TECHNICAL BULLETIN

SUBJECT: INSTALLATION OF CABIN HEAT DUCT (FIBER GLASS) ASSEMBLIES.

PN 369D22009-101 AND PN 369D22009-103

MODELS AFFECTED: All 500 Model 369H Series Helicopters equipped with PN

Figure 1. Installion of Fiberglass Cabin Heat Ducts,

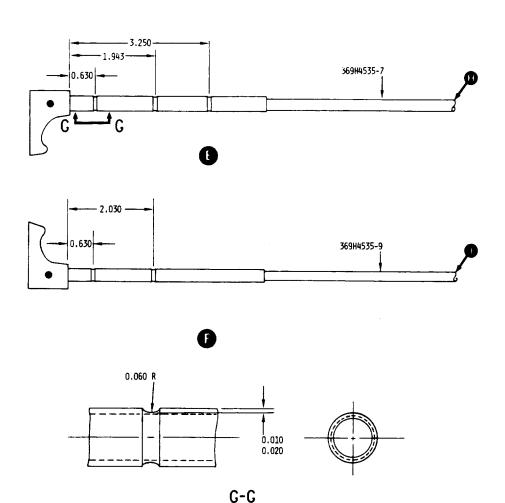
The information given in this Service Information Notice lists instruction for replacement of the existing Lexan—type cabin heat duct, PN 369H92475—83, with a new fiberglass—type heat duct, PN 369D22009—and for replacement of existing 369H92475—31 duct with a new fiberglass duct assembly, PN 369D22009—103. The fiberglass duct configuration is designed to provide greater resistance against heat, deformation and wear

It is to be noted that PN 369H4535-7 and PN 369H4535-9 control cable assemblies must be utilized with the new 369D22009-101 fiberglass duct configuration. Existing PN 369H4535-3 and -5 control cable assemblies must therefore be replaced, or reworked per this Notice to the 369H4535-7 and -9 configurations, to be compatible with the new fiber-glass duct installation.

- a. Remove outer box from 369H92475-83 cabin heat duct and canopy frame. (Refer to referenced HMI Appendix A.)
- b. Remove hardware securing heating and anti-ice control cable assemblies to heat duct; remove -83 heat duct assembly. Remove 369H92475-31 cabin heat (lower) duct assembly. (See Figure 1.)
- c. Using file or equivalent, rework control handle shafts to provide detents, per dimensions shown in Figure 1.
- d. Install new PN 369D22009-103 and 369D22009-101 fiberglass heat duct & assemblies.
- e. Install control cable assemblies to new -101 duct assembly; secure clamps and position retainers with hardware as shown.
- f. Adjust spring plunger in position retainers so that 5 to S pounds of force is required to pull 369H4535-7 and -9 controls out of locked position in detents.
- g. Remove aft bulkhead access cover: open plenum chamber access door. (Refer to Section 2 of Basic HMI.

- 1. 0.165 0.177 DIAMETER HOLE TO MATCH HOLES 1N 369D22009-5 BLOCK AND 369D28059-11 AND 369D28059-13 POSITION RETAINER 2 PLACES.
- 2. 0.165 0.177 DIAMETER HOLE TO MATCH HOLES 1N 369D22009-31 AND 369D22009-41 CLAMP ASSEMBLIES 4 PLACES.
- NAS620C6 WASHER 8 REQUIRED NAS601-4P SCREW 8 REQUIRED.
- 4. 369H92475-109 CLIP RFN 100 x 0.38 DIAMETER BLACK TUBING.
- 0.250 DIAMETER HOLE THUR 369D22009-45 COVER TO MATCH 369D22009-51 DUCT ASSY, INSTALL EXISTING SCREW. 88-352-1
